CITY OF CODY
PLANNING, ZONING AND ADJUSTMENT BOARD
TUESDAY, SEPTEMBER 24, 2013
CITY HALL COUNCIL CHAMBERS @ 12:00 NOON

AGENDA

**CITY OF CODY
PLANNING, ZONING AND ADJUSTMENT BOARD
STAFF REPORT**

**CITY OF CODY
PLANNING, ZONING AND ADJUSTMENT BOARD
STAFF REPORT**

C.S.D. REVIEW ARCHITECTURAL SITE & LANDSCAPING PLAN

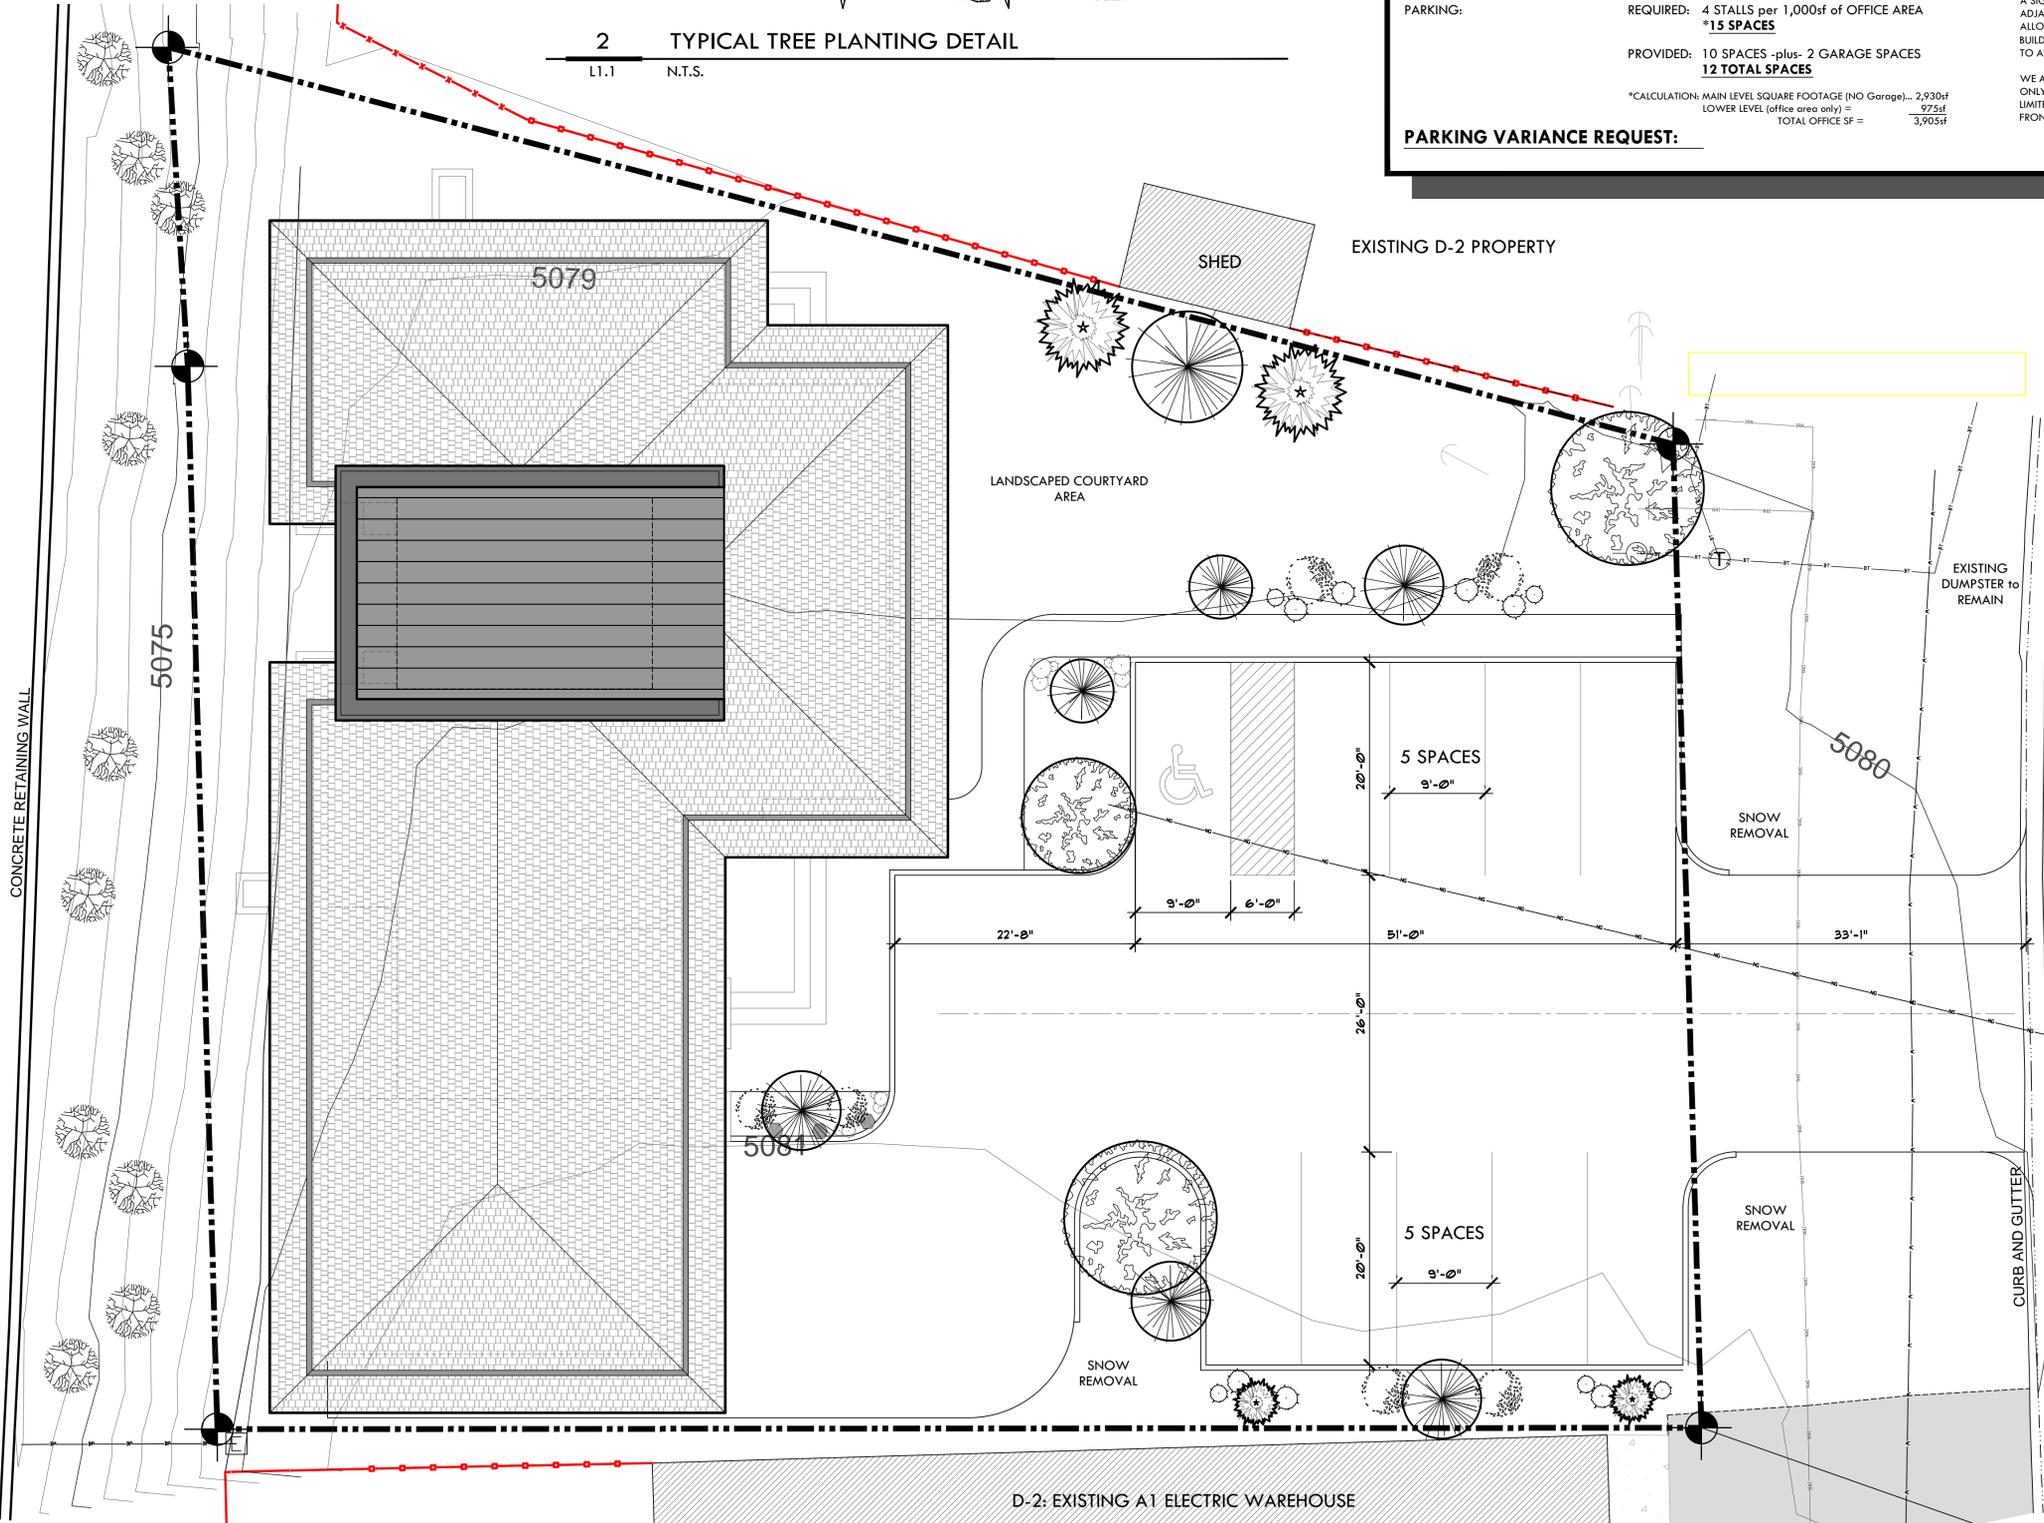
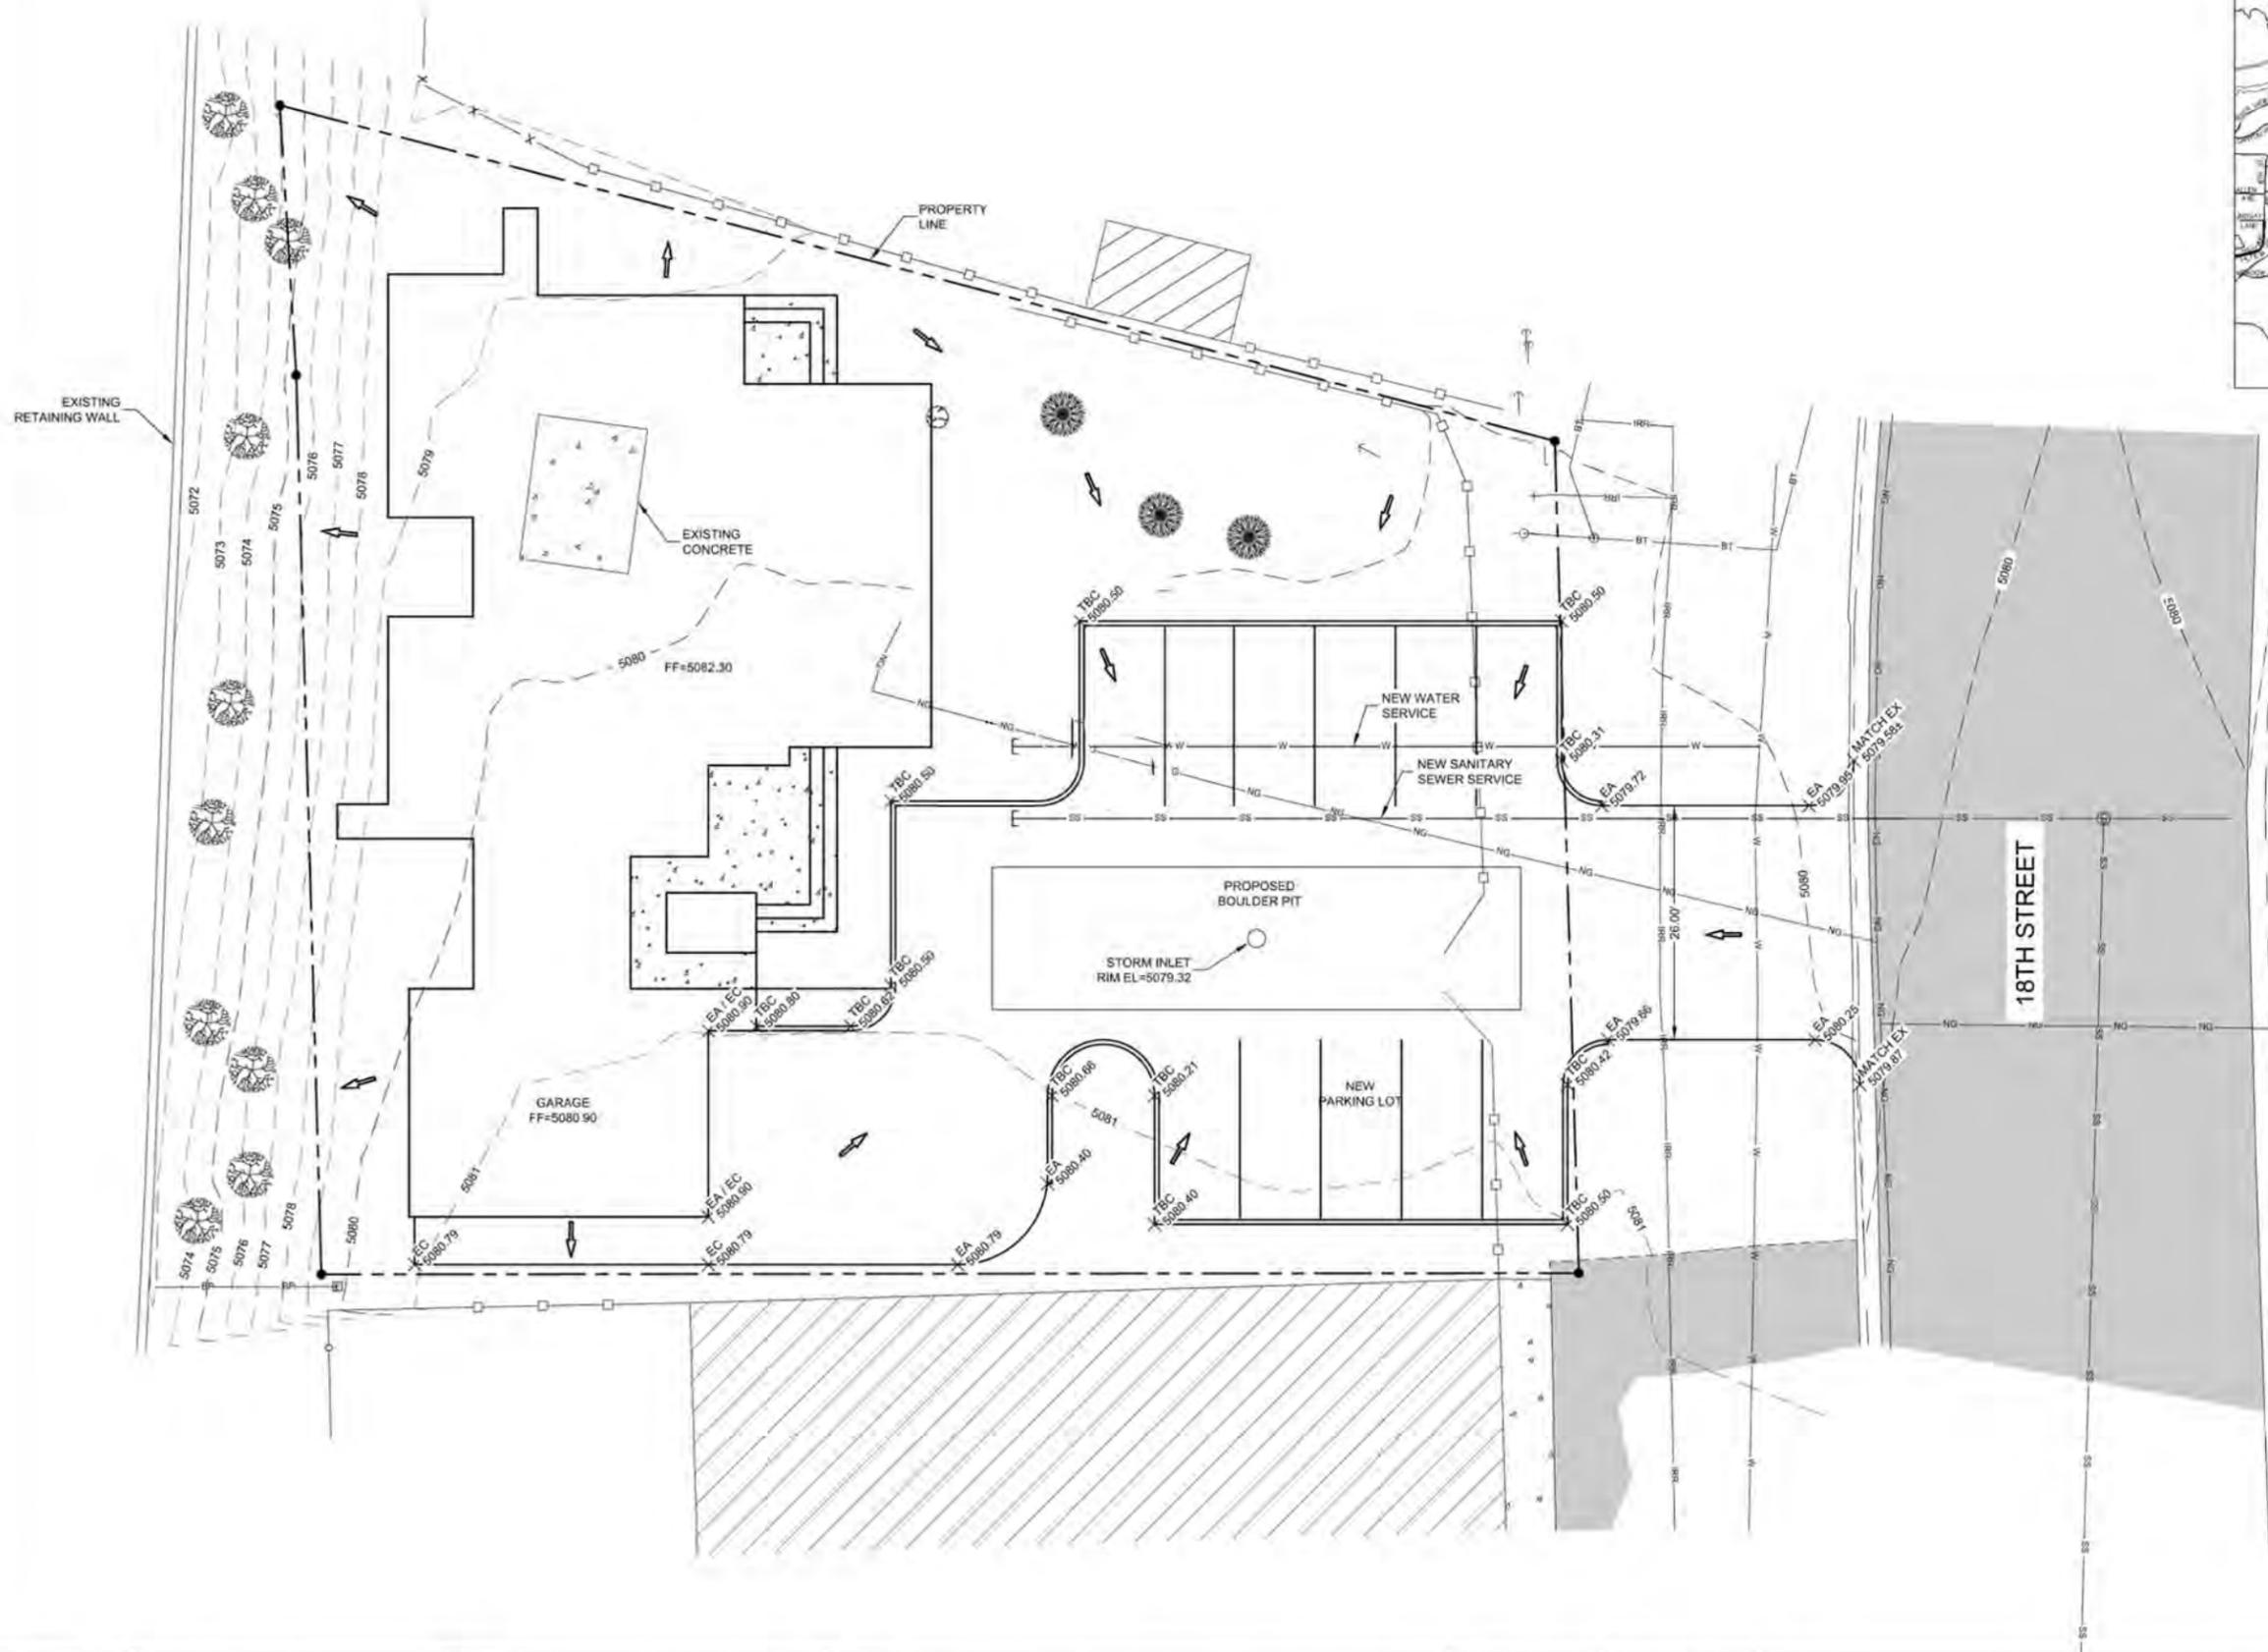
The proposed general landscaping plan has been provided. It includes grass, limestone landscaped beds, and a landscaped courtyard area. The quality will be reflective of the high-quality architecture of the building. While all landscaping details are not provided, most of the basic factors are noted, including an automatic irrigation system, sleeves under the pavement to extend irrigation to all parts of the site, and type of groundcover. An existing raw water tap is shown on the plans at the northeast corner of the property.

The parking ordinance requires office buildings to provide one space per 250 sq. ft. of gross floor area. The 5,237 square feet of office building (w/o garage) would require 21 parking spaces according to the standard ratio. The site plan shows 12 spaces. The parking ordinance allows the Planning and Zoning Board to consider other appropriate parking ratios "based on reliable data, such as parking data from a highly comparable facility or a parking demand study prepared by a qualified parking consultant or engineer". The application does not extensively address the reasoning and the applicant may wish to expand on the point at the hearing.

One ADA parking space is required and is shown on the landscape plan. The dimensions need to be modified to meet van-accessible standards—an 11-foot wide stall and minimum 5-foot wide unloading area. There is not sufficient detail to determine if the ADA access routes meet applicable codes.

1. Review and approval of the storm water plan by the City engineer.
2. That parking lot lighting be added to the civil plans, and installed.
3. That the ADA parking space and accessible route to the building be included on the civil drawings according to applicable code.

1 EXTERIOR ELEVATION: EAST - ENTRY SIDE
A2.1 1/4" = 1'-0"

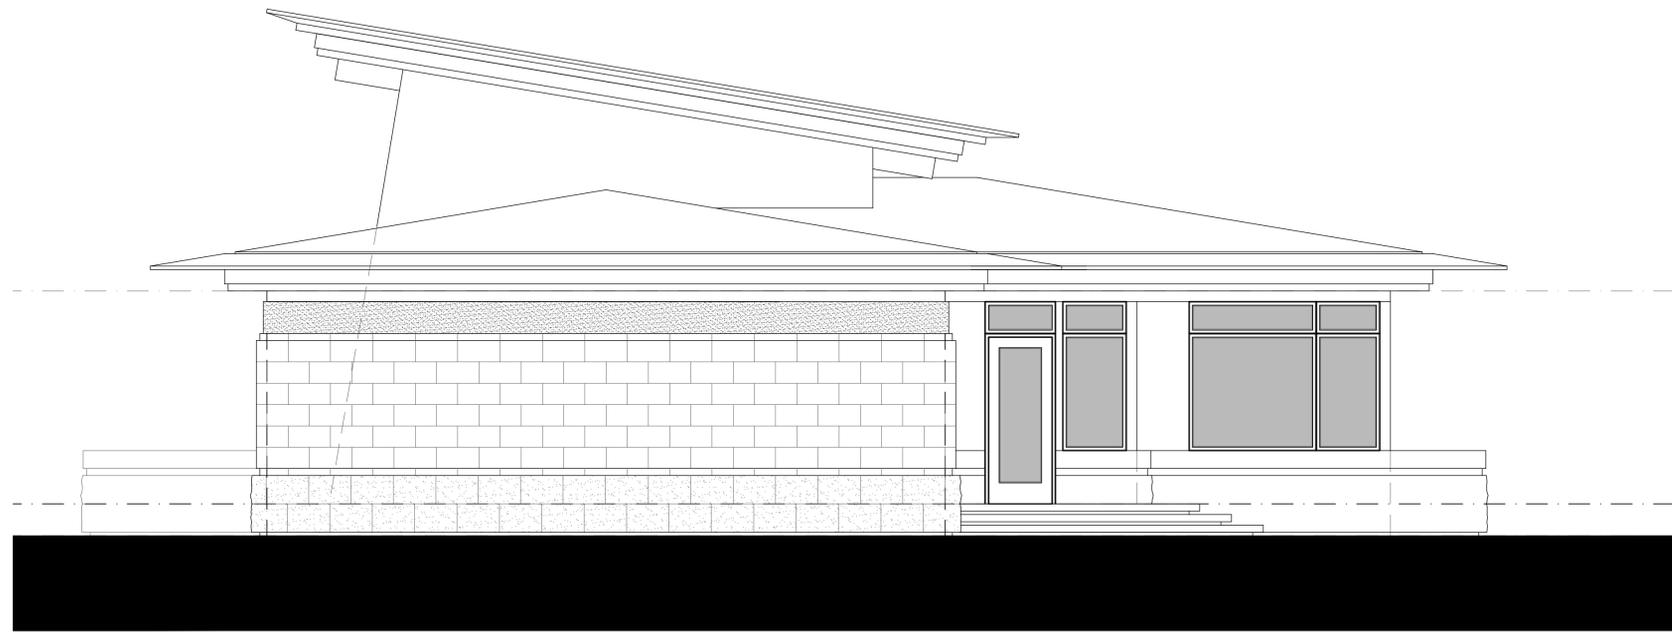
The architectural drawings and elevations are attached. It is a high-quality modern building, sided with earth toned E.I.F.S and stained fir beams and banding. Fascia, trims and flashing are black metal to match the windows. The architect indicates that the plan has changed somewhat from the rendering in that a standard hipped roof would be used, which would eliminate the "lookout" extension above the roofline. Also, as noted on the plans, the deck has been eliminated. Due to fire/building code the
